Just to Clarify #4

Double Face MGS w-beam

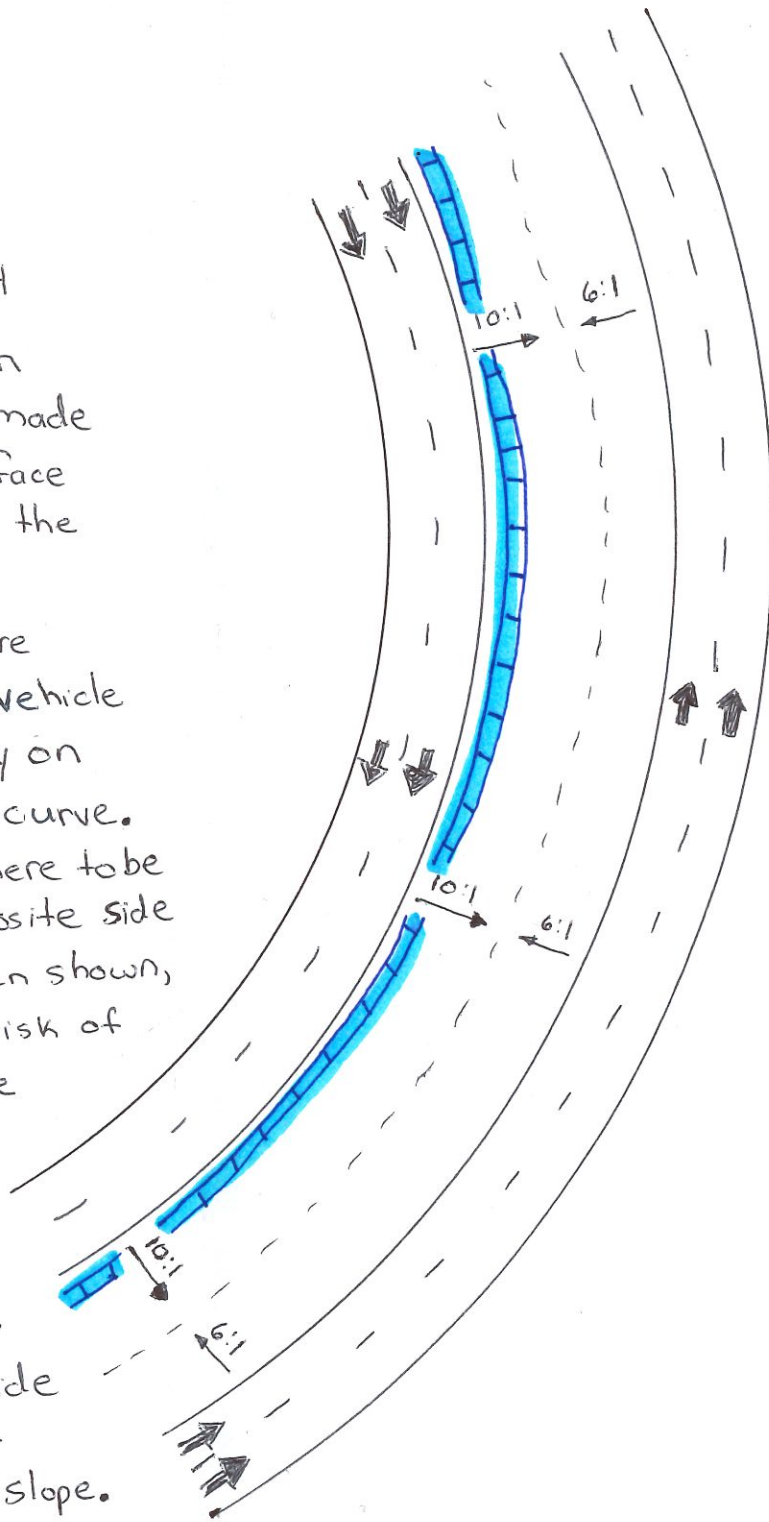
in your response, an argument could be made to place the double face MGS w-beam along the shallower slope, as shown, because there is more risk of a vehicle leaving the roadway on the outside of the curve. If the barrier were to be placed on the opposite side of the median, then shown, there is a higher risk of a vehicle hitting the double face MGS w-beam from the reverse direction and the vehicle may override or underide the w-beam after traversing up the 6:1 slope. The double face MGS w-beam as shown may be a safer option for an errant vehicle.
